#15183: Service Update for Inventory and Customer Vehicles - Driver's Side Front Roof Ditch Molding Water Leak - (Mar 18, 2015)

Subject: 15183 – Service Update for Inventory and Customer Vehicles – Driver's Side Front Roof Ditch Molding Water Leak – Expires with Base Warranty

Models: 2015 Cadillac Escalade
2015 Chevrolet Tahoe
2015 GMC Yukon

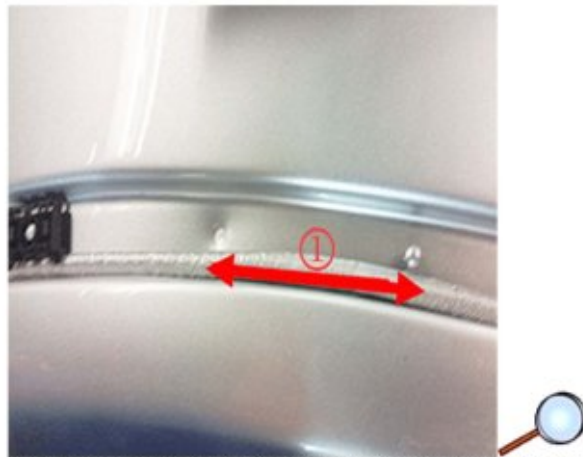
1. Remove the left roof panel joint finish molding (1). Refer to *Roof Panel Joint Finish Molding Replacement* in SI.

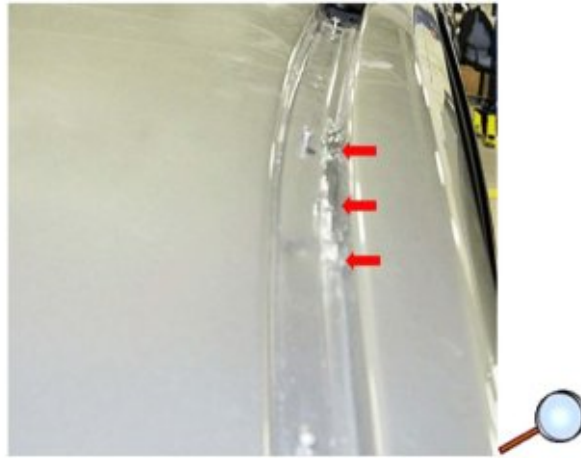
2. In the area between the forward roof weld and the second roof stud (1), inspect for voids/gaps in the seam sealer **along the outboard edge** of the roof ditch.

Note: During sealer application, avoid excess sealer build up within the ditch, while assuring there are no voids in the full bead of sealer.

3. Overlapping at least 25 mm (1.0 in) each side, apply a maximum height 0.4 mm (0.157 in) bead of Kent Automotive High-Tech™ Clear Seam Sealer, the length of the area.
